Lew W. Myers
Vice President216-280-5915
Fax: 216-280-8029September 9, 1998
PY-CEI/NRR-2322LUnited States Nuclear Regulatory Commission
Document Control Desk
Washington, DC 20555Perry Nuclear Power Plant
Docket No. 50-440
License Amendment Request: Improved Licensing and
Design Basis For Isolation of the Feedwater Penetrations

SUMMARY

**SUMMARY DESCRIPTION OF THE PROPOSED TECHNICAL SPECIFICATION AND
UPDATED SAFETY ANALYSIS REPORT (USAR) CHANGES**

Drawings of the current configuration are provided in the following Figures.

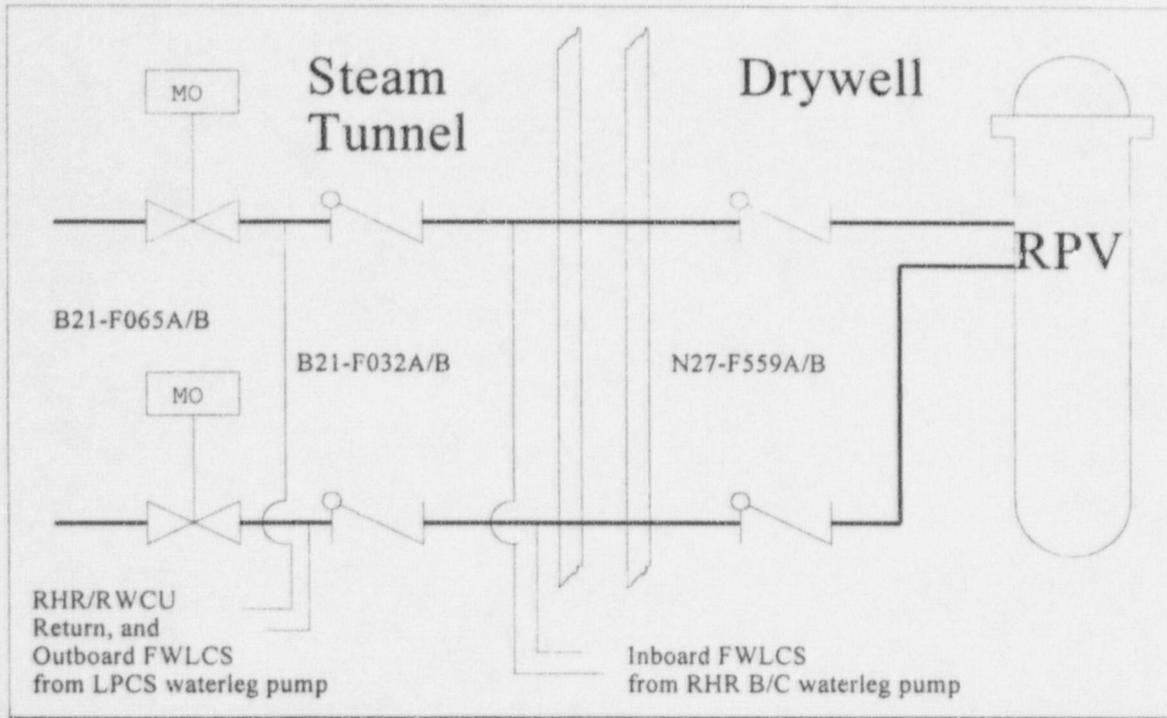
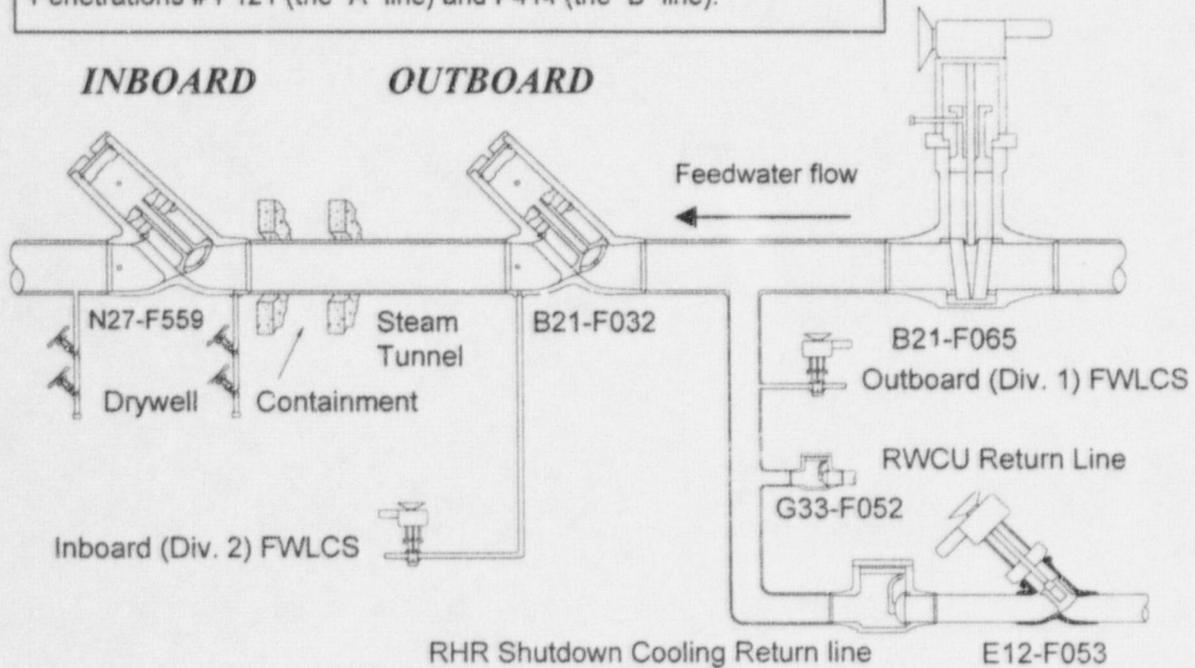
- There are no automatic isolations of Feedwater lines on accident signals, so that Feedwater can maintain flow to the reactor vessel. As noted in ANSI/ANS-56.2, greater plant safety is assured by maintaining a feedwater supply to the reactor (this makes the Feedwater penetrations a unique case, since remote-manual actions are acceptable for isolation despite the non-safety classification of the system).

- Two piston lift style check valves are in each Feedwater line for isolation of significant flow from a Feedwater line break outside containment. These anti-waterhammer valves are not designed for air tests.

- A third valve (Motor-operated valve (MOV), gate valve) is provided for long-term, high integrity leakage protection when, in the judgment of the operator, continued makeup from Feedwater is unnecessary or is not available. This valve provides a tight water seal against postulated radioactive leakage. As part of the licensing basis discussions, the NRC agreed that the non-safety, non-seismic Feedwater piping outboard of the MOV would remain intact at least until this gate valve can be remote-manually isolated by plant operators.

- FWLCS provides a manually initiated seal water system. The seal water system permits water versus air testing of the valves in the penetration (air tests were only required for the MOV stems and bonnets).

- FWLCS consists of two redundant seal water sources which inject into the Feedwater lines between the valves. The line between the valves is currently assumed to fill with water and pressurize within \approx 1 hour, based on a 20-minute control room operator manual action.

PART III. Brief Summary of Proposed Improved Feedwater Penetration Configuration

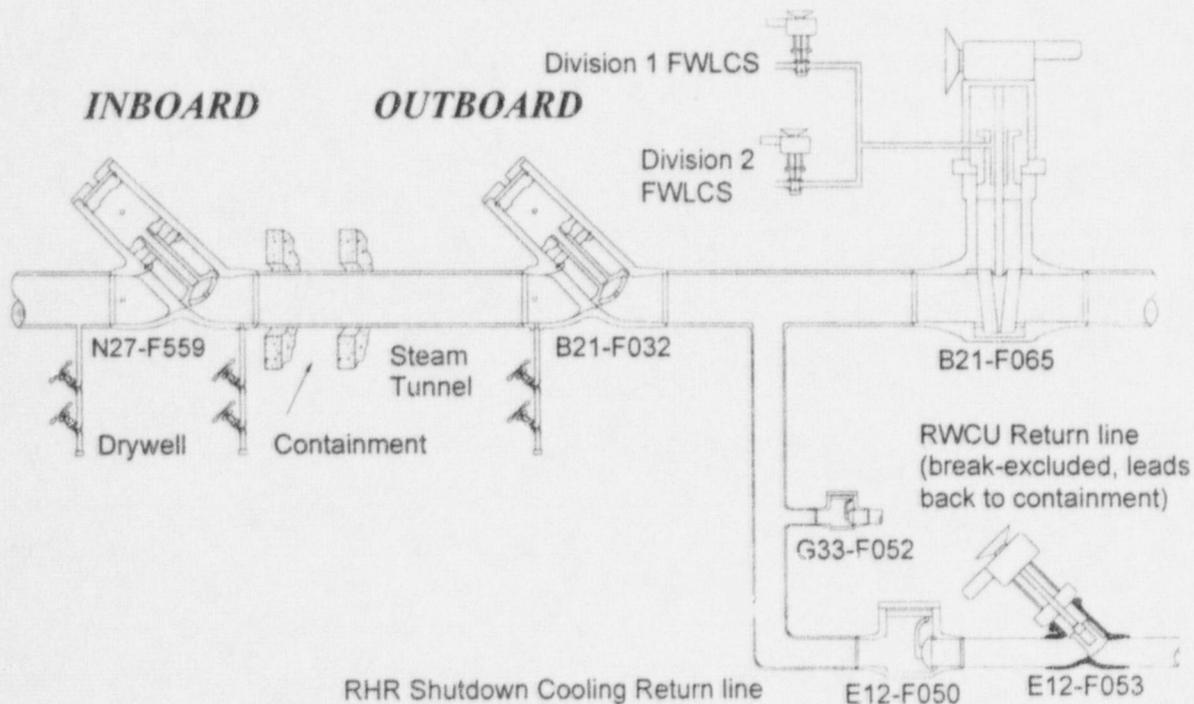
- The FWLCS would remain a manually initiated system, but rather than attempting to fill the large piping volumes between the valves, the two redundant FWLCS lines would be routed to the bonnet of the existing third motor operated gate valve in each Feedwater line. These valves are already assumed to be successfully closed by the operator after the start of the event. Once the FWLCS is lined up, one of the redundant pumps would be aligned to the valves to provide the water seal to the penetration much faster than using the former technique of filling the entire line. The gate valve bonnet and seat areas would begin to fill and pressurize when the seal water reaches the valve, and the seal would be established within several minutes.

- Although the current licensing basis already assumes that the third valve will be remotely manually closed by the control room operator following a loss-of-coolant-accident (LOCA) to provide the long term, high integrity leakage protection, an even higher confidence level on closure of these valves will be provided by a design change and revisions to plant emergency procedures. The procedures will direct operators to implement an alternate division of electrical power to the gate valves, in the event that the valves normal power

supply is lost. An alternate division of power such as this is not a new concept; the operators already receive training on a similar arrangement that is utilized in the PNPP licensing basis for the Station Blackout event. The capability to provide power from Division 3 will be a permanent design modification, but physical and electrical separation between Divisions 1 and 3 will be maintained by employing two features:

- 1 Normally open, fused disconnect switches at both ends of the circuit, and
 - 2 Fuses normally stored out of the circuit.
- The water seal provided to the disc/seat of the third (gate) valve would provide for a water test on these seats, at $\geq 1.1 P_a$. One method would be to initiate FWLCS to the bonnet, and measure leakage past the seat by collecting the leakage in the line outboard of the gate valves. Water leakage past the gate valve seats would continue to be added into the Primary Coolant Sources Outside of Containment Program. This Program is in place to protect the assumptions of the radiological dose calculations for PNPP. This is how the water leakage from the Feedwater penetrations is currently addressed in the PNPP dose calculations.

- Due to the injection of the seal water into the stem/bonnet area of the gate valves, the appropriate test for stem/bonnet leakage is to identify any water leakage outside of the piping system, and eliminate it. This test will be performed during the system walkdowns performed per the Technical Specification 5.5.2 Primary Coolant Sources Outside Containment Program, at pressures > 1000 psig. This water test approach for the stem/bonnet will ensure post-accident leakage outside of this Class 2 Feedwater piping is eliminated, and will not adversely affect the PNPP radiological dose calculations.

- The check valves would no longer need to maintain a 1 gpm leakage limit, since the lines would no longer need to be filled with water to make the FWLCS function. It would still be necessary to ensure that the check valves are exercised closed so that significant flow from a Feedwater line break outside of the containment could be prevented. This is the ASME (American Society of Mechanical Engineers) Code Class 1 function of the valves. As noted in Generic Letter (GL) 89-04 Position 3 "Back Flow Testing of Check Valves", many plants were not performing back flow testing of any kind prior to 1989 on check valves that perform a safety function in the closed position to prevent reversed flow. Main Feedwater check valves were listed as an example of such valves. The GL noted that tests on check valves that perform a safety function in the closed position to prevent reversed flow should be performed. "Category C" tests on such "safety function check valves" were described as proving that the disc closes on its seat. An example method discussed for such safety function Category C tests is a visual observation. Upon implementation of this amendment, the PNPP Feedwater check valve closure function will be verified by an inspection of the valve internals at an appropriate frequency as determined by the Inservice Testing Program (ISTP). The design change will incorporate new taps off of the line adjacent to the check valves so that this necessary inspection can be completed (for example, by using boroscopic inspections). The check valves would be removed from the hydrostatic testing program, as such additional testing is not necessary to ensure their closure capabilities to prevent significant flow following a postulated Feedwater line break outside containment. Hydrostatic leak tests of the check valves are also not necessary to address the radiological dose calculations (since the feedwater line high integrity leakage barrier is provided by the gate valves). This is addressed in more detail in Section IV, below.
